Tarheel Lodging Redevelopment

Certificate of Appropriateness Phase-II Modifications

August 23, 2022

14UPDATED 8-30-22; 2nd Submittal Revised 11-8-22

**OAS-3
Layout &
Planting Plan**

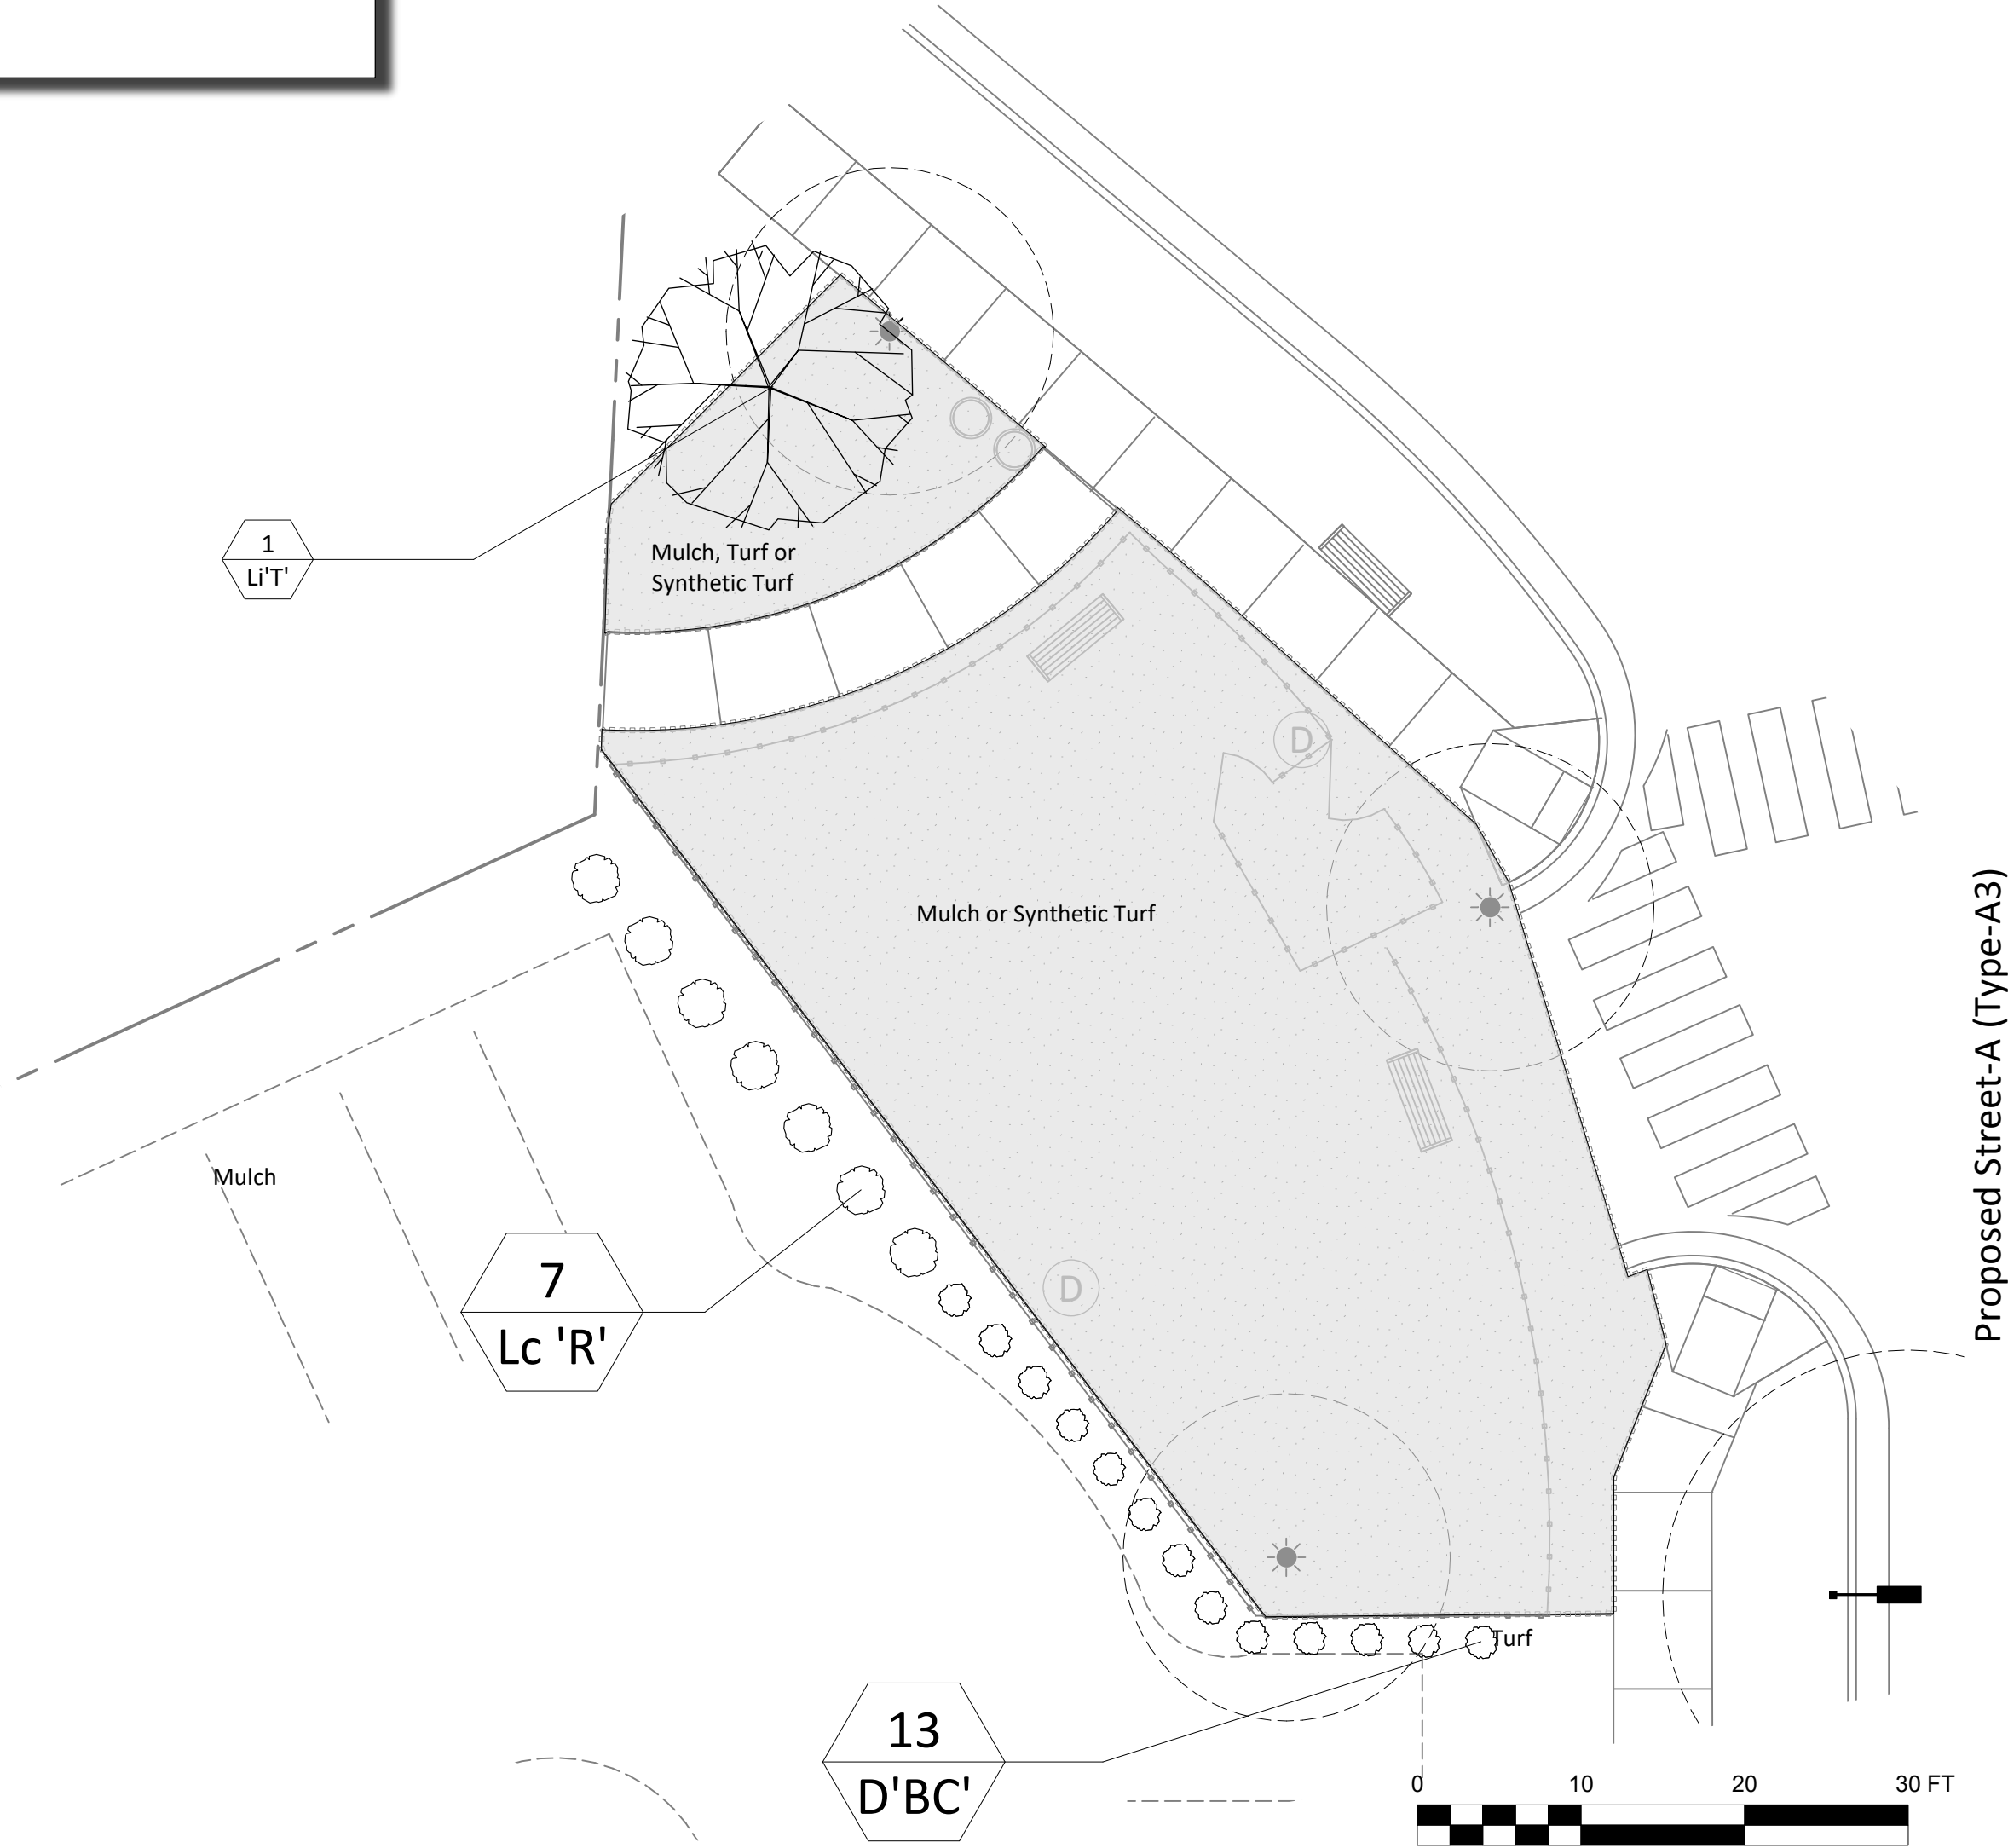
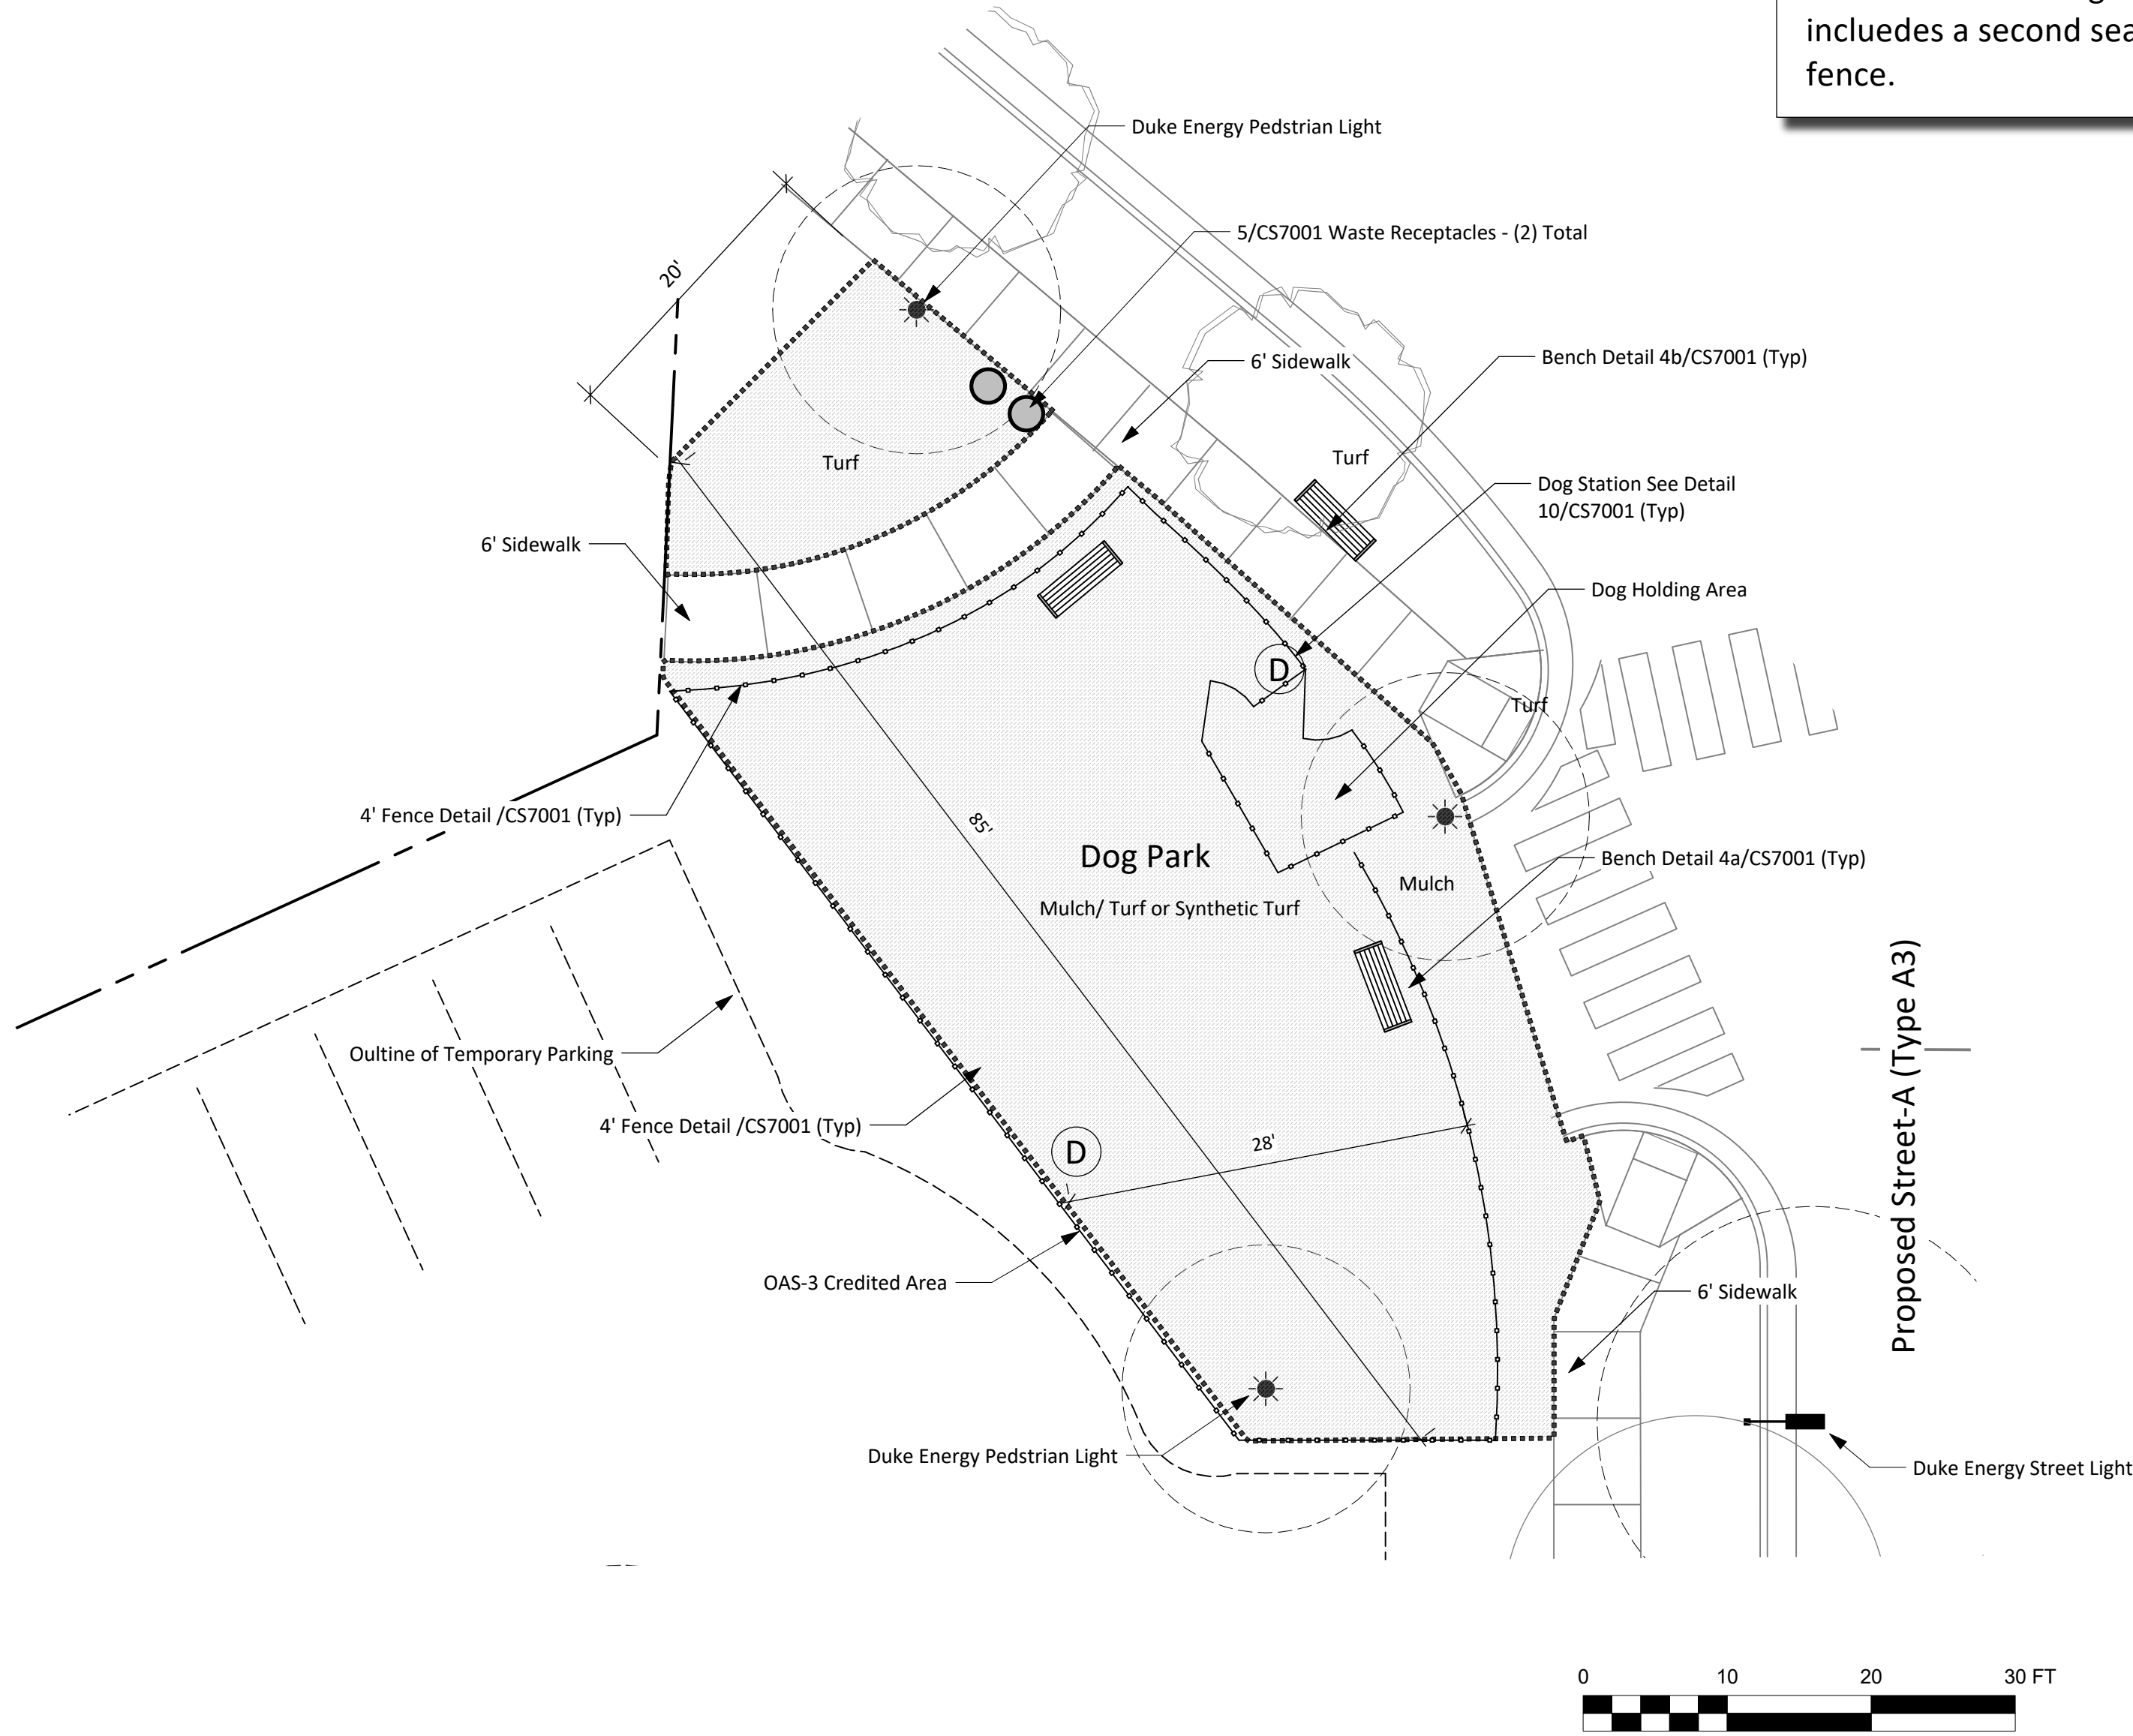
2	10-14-22	Revise OAS-3
1	10-25-19	Staff Comments 10-22-19; adjust street/area lights per Duke Energy & OWASA reqmnts.
No.	Date:	Issue Notes:
